AURANGABAD PRESSINGS

Corrective / Preventive Action

Part Name: Bracket ABS MTG

Part No: B2SU01102 O

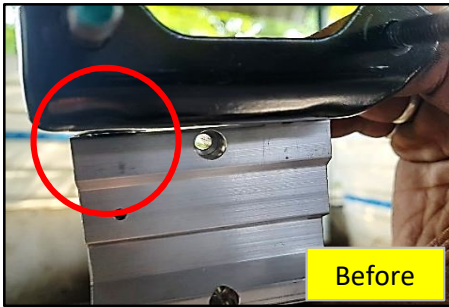
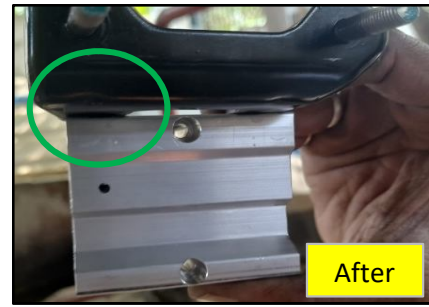
Bracket ABS MTG Not Rest on ABS Modulator.

Bracket ABS MTG Flattness Not OK

New Flattning Tool for Bracket ABS MTG implemented.

- 1) Flattning operation added for Bracket ABS MTG.
- 2) Operation Sequence To Be changed from next lot.
